# Access Compliance Report

## Public Rights-of-Way

Intersection ID: 13541	Main Street: CENTRAL_AV	Cross Street: EASTCREST_DR	Location: NW
ADA ID: 6FC3F8D520C7	Ramp Type: Perp	Initial Pass/Fail: Fail	Overall Compliance: No
		Severity Score: 10

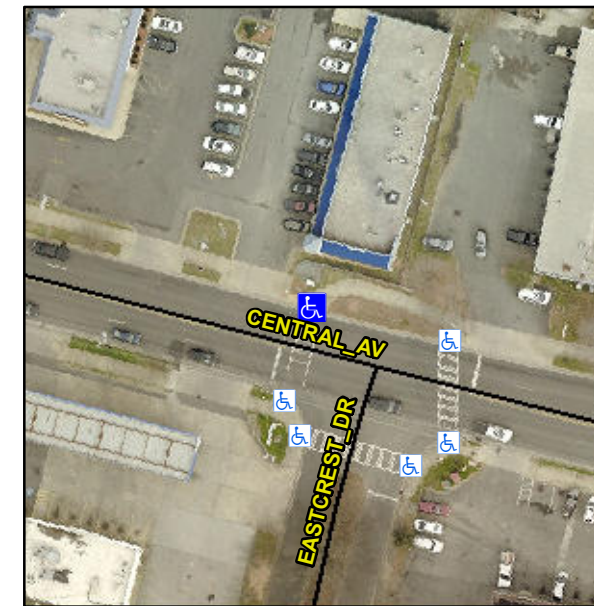
**Not Found, R304.5.1**

Compliance	Description	Data	Compliance	Description	Data
N/A	Ramp Length (in)	97.5	Yes	Ramp Slope (%)	6.3
No	Ramp Width (in)	47.5	Yes	Ramp XSlope (%)	3.8
N/A	Flare Type LT	N/A	N/A	Flare Type RT	N/A
N/A	Flare Slope LT (%)	N/A	N/A	Flare Slope RT (%)	N/A
N/A	Flare Traversable LT?	N/A	N/A	Flare Traversable RT?	N/A
N/A	Landing Length (in)	N/A	N/A	DWS Provided?	N/A
N/A	Landing Width (in)	N/A	N/A	DWS Contrast?	N/A
N/A	Landing Slope (%)	N/A	N/A	DWS Length (in)	N/A
N/A	Landing X Slope (%)	N/A	N/A	DWS Full Width?	N/A
N/A	Landing Curb? (Y/N)	N/A	N/A	DWS Offset (in)	N/A
N/A	Shared Landing?	N/A			
N/A	Gutter Ponding?	N/A	N/A	Gutter Slope (%)	N/A
N/A	Gutter Lip Ht (in)	N/A	N/A	Gutter X Slope (%)	N/A
N/A	Painted X Walk1?	Yes	N/A	Painted X Walk2?	N/A
	X Walk 1 Direction	To SW		X Walk 2 Direction	N/A
N/A	X Walk 1 Width (in)	111.0	N/A	X Walk 2 Width (in)	N/A
	X Walk 1 Slope (%)	4.2		X Walk 2 Slope (%)	N/A
	X Walk 1 X Slope (%)	3.9		X Walk 2 X Slope (%)	N/A

**Remove & Replace Entire Ramp.**
